AFFORDABLE HOUSING
DEVELOPMENT SSD-83256463
ARCHITECTURAL DRAWINGS
THE BOULEVARDE
PUNCHBOWL
COLLINS AND TURNER
SEPTEMBER 2025

No	Date	By	Note
B	9/12/2025	DC	For RTS

Project	
Affordable Housing Development SSD-83256463 150 The Boulevard and 34 Dudley Street Punchbowl, NSW

Drawing Title Section 3 and 4

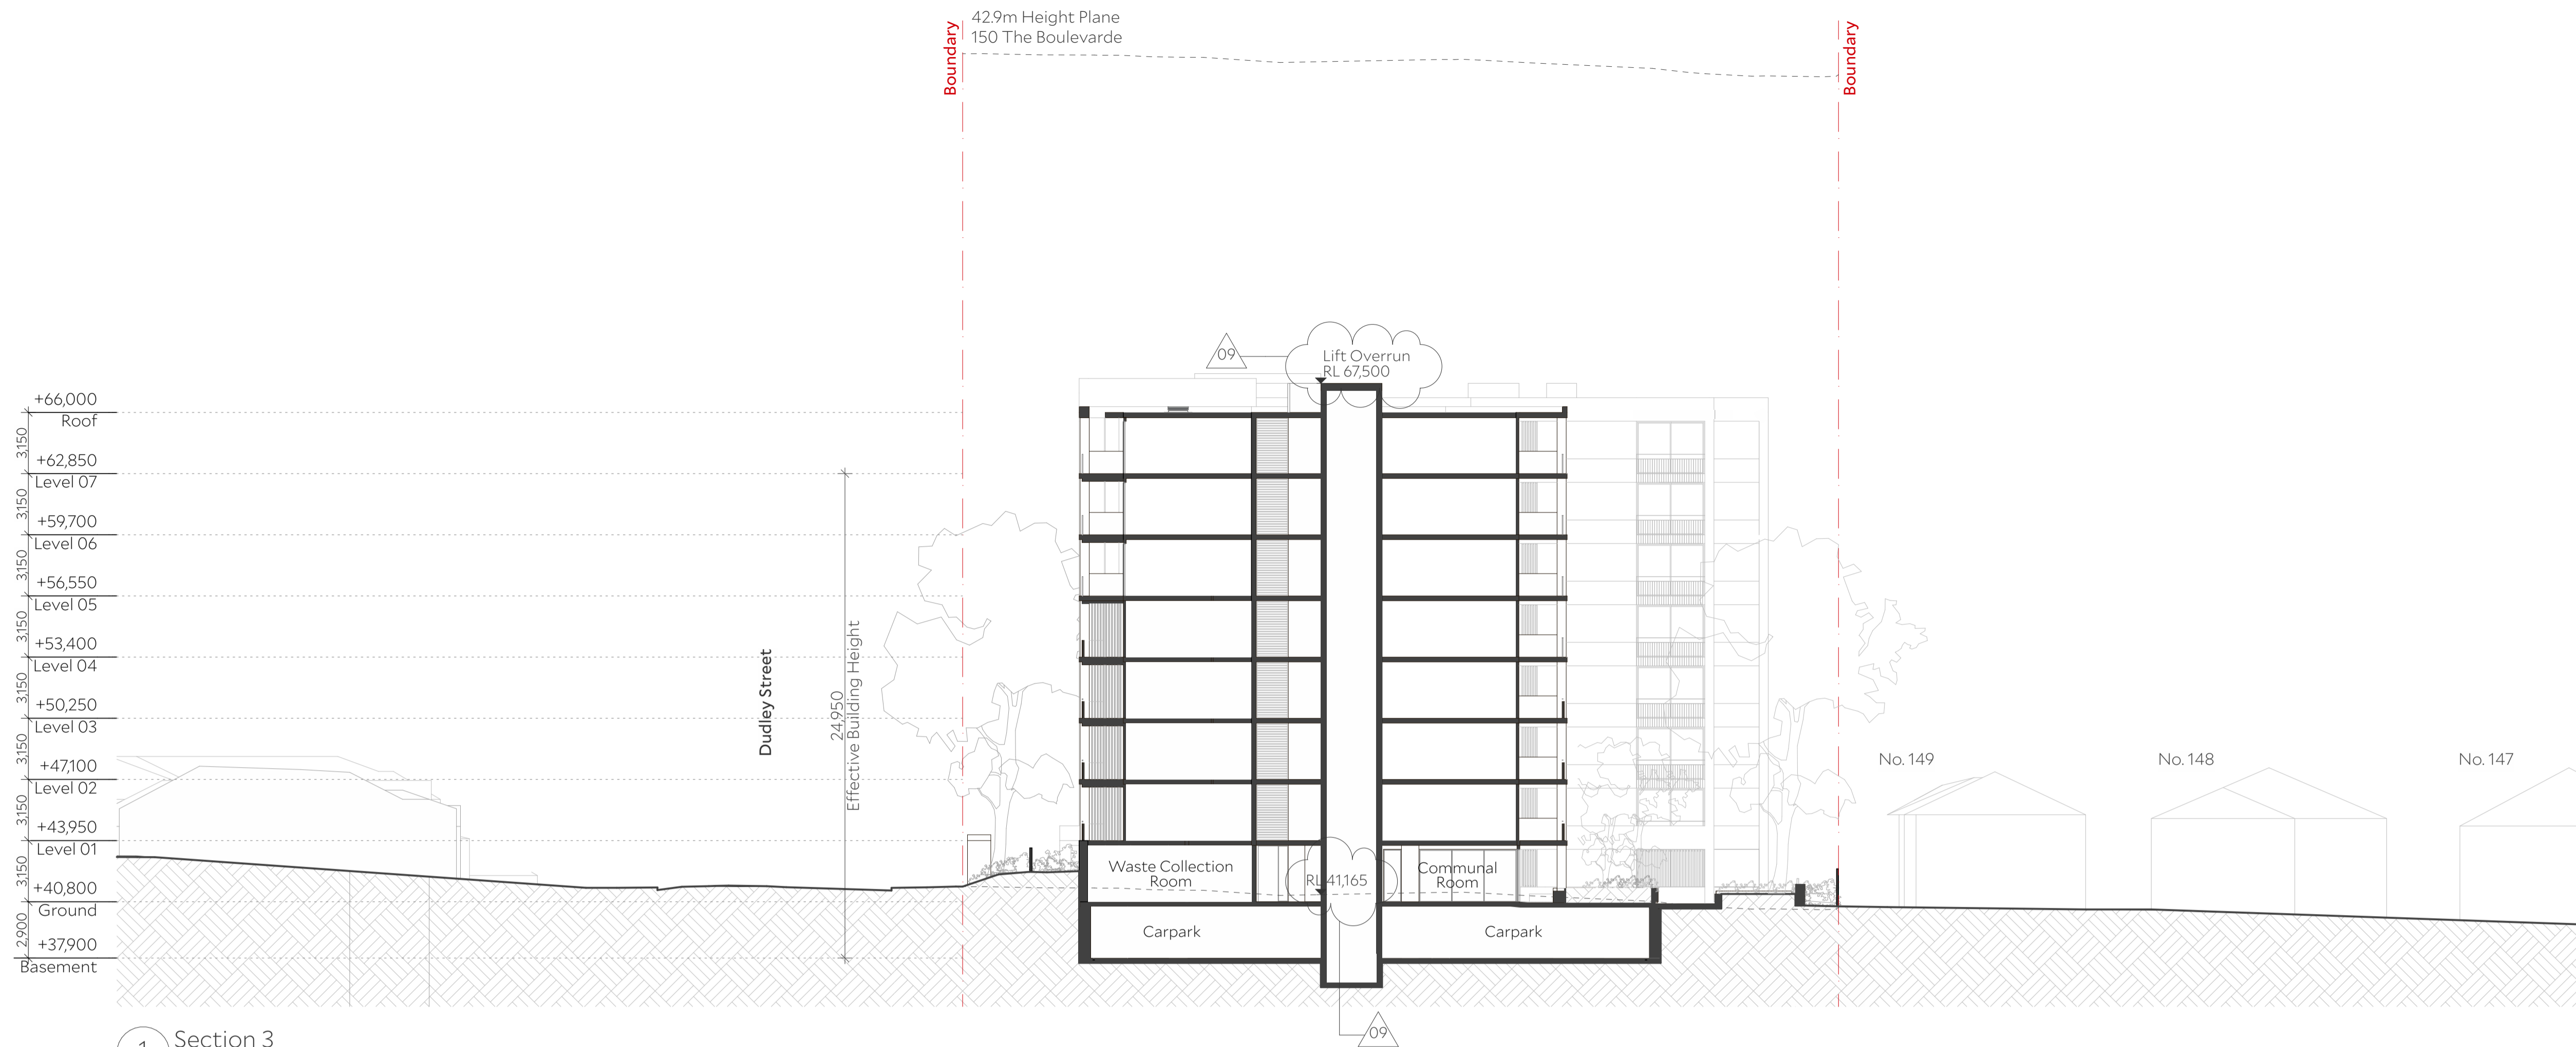
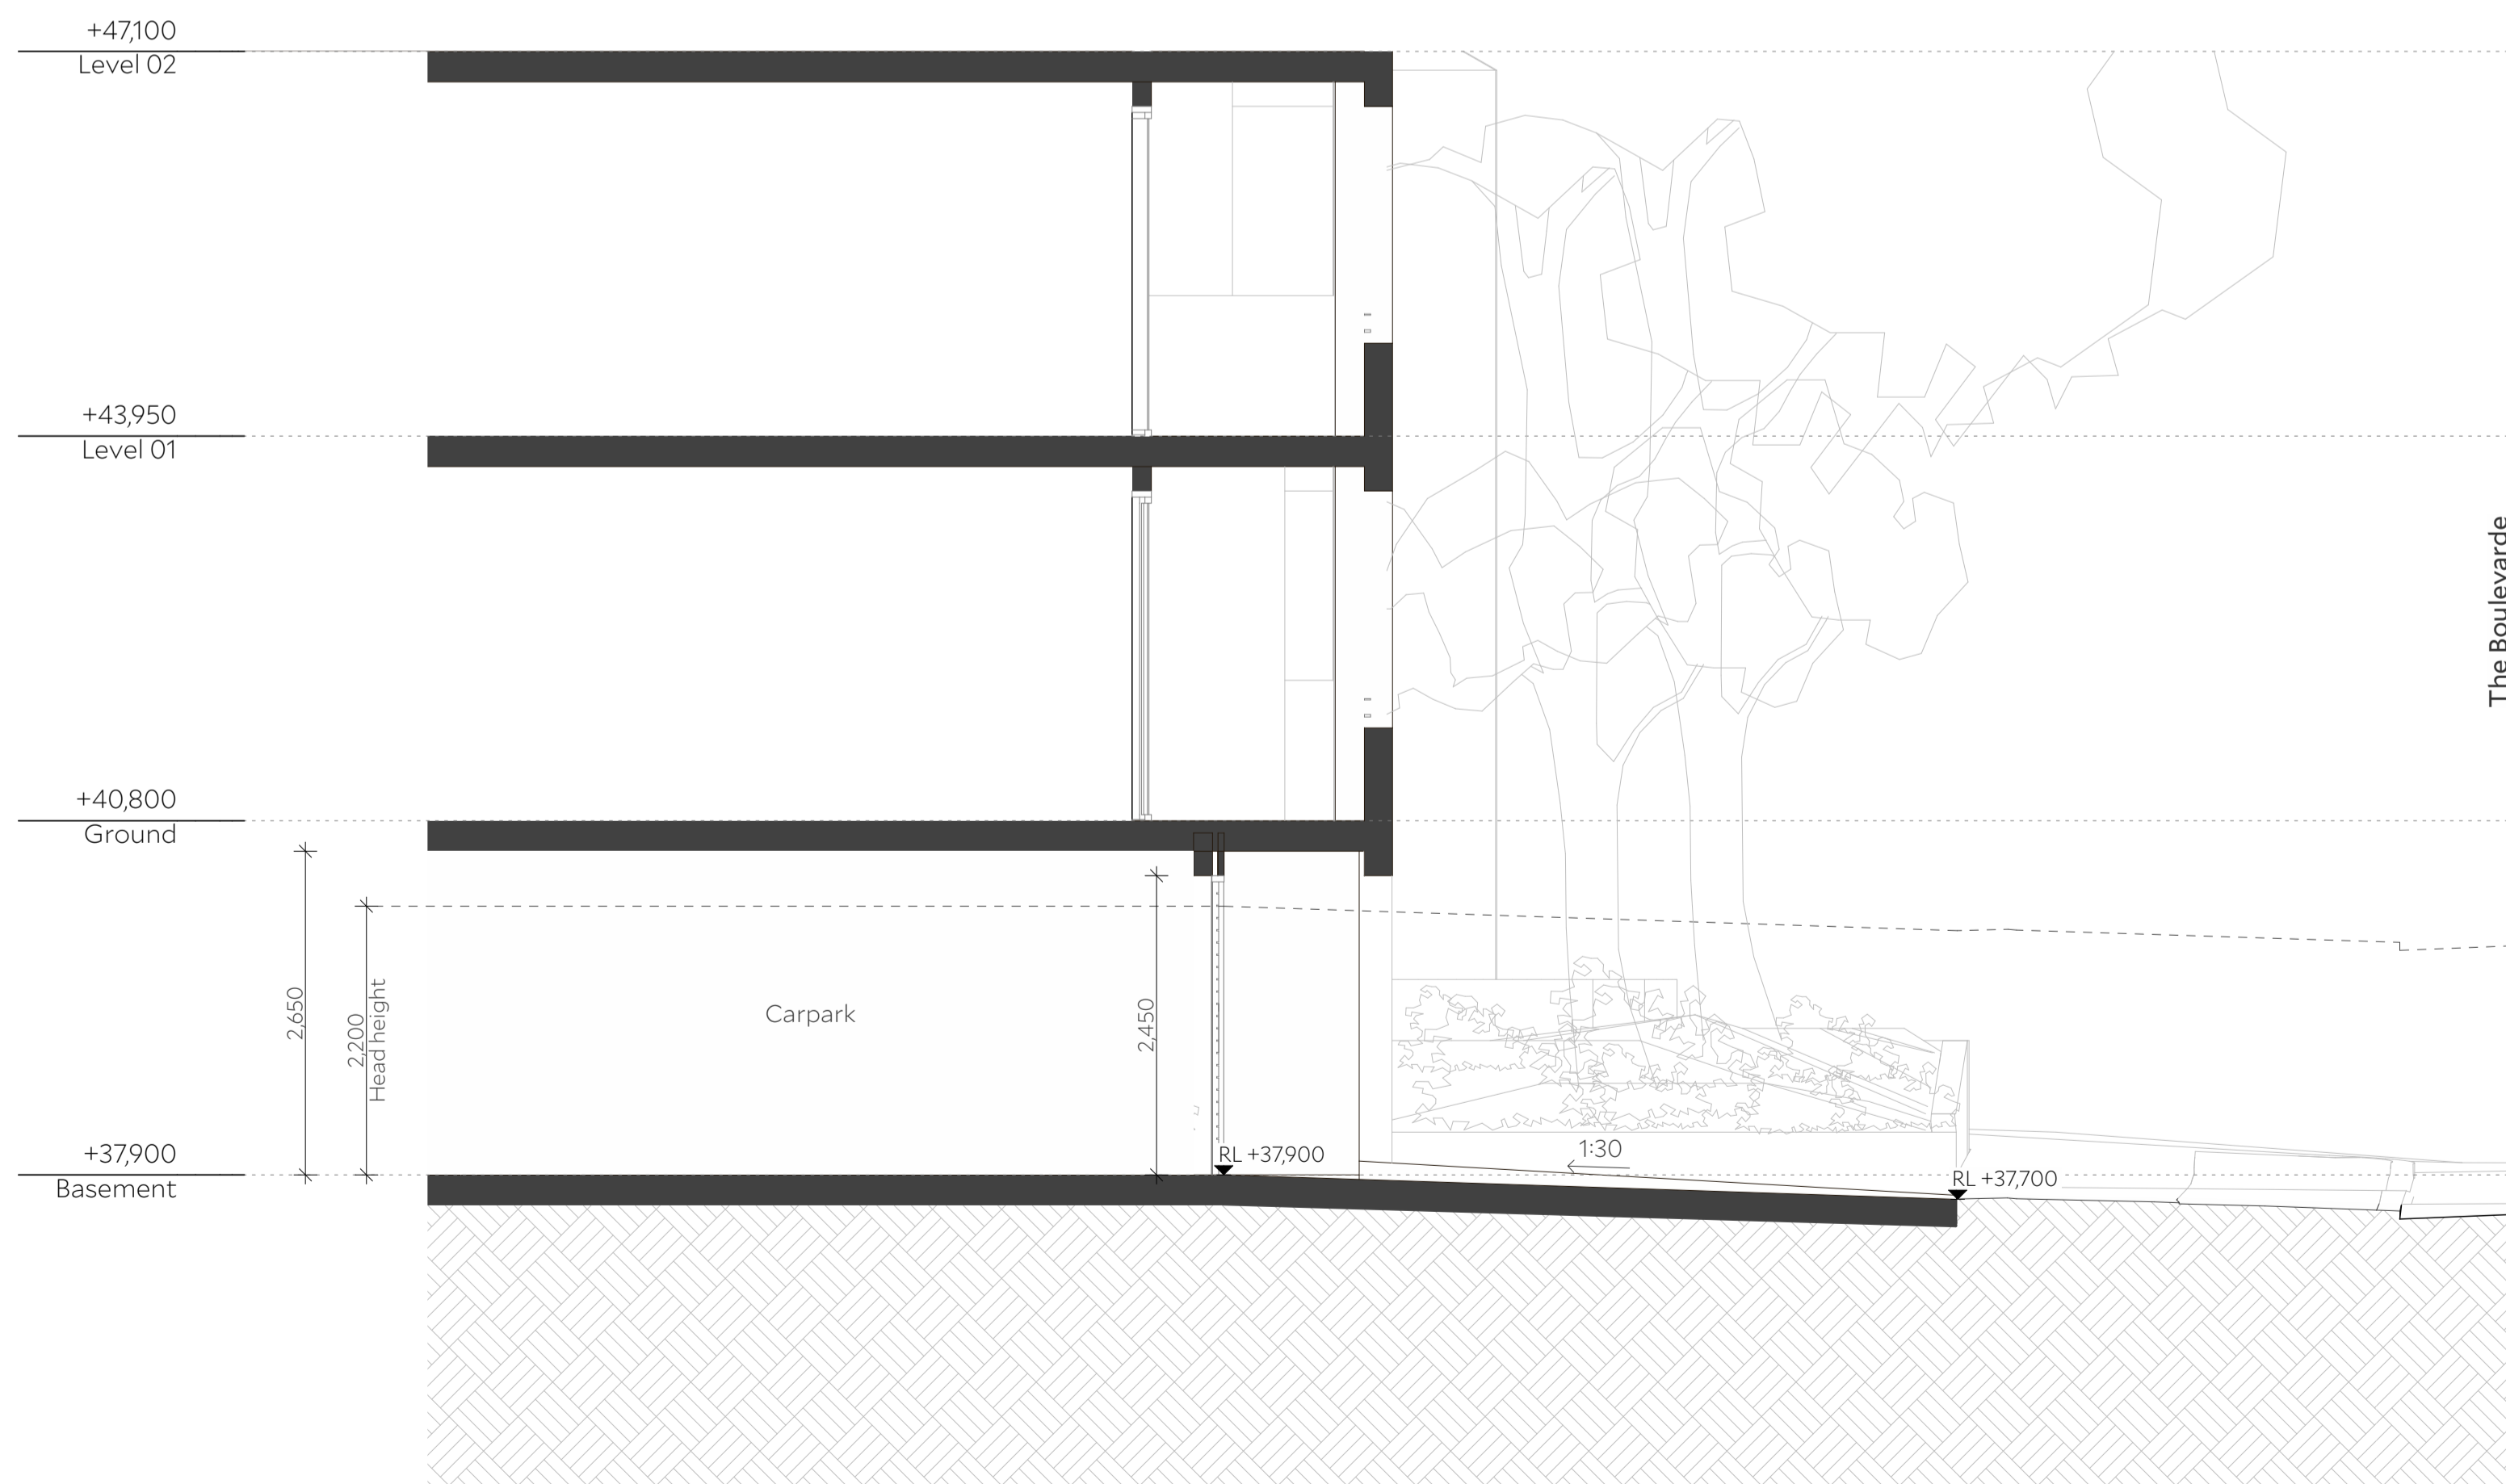
ID	Name
09	Reduced levels added Refer to RTS Item DPHI 14
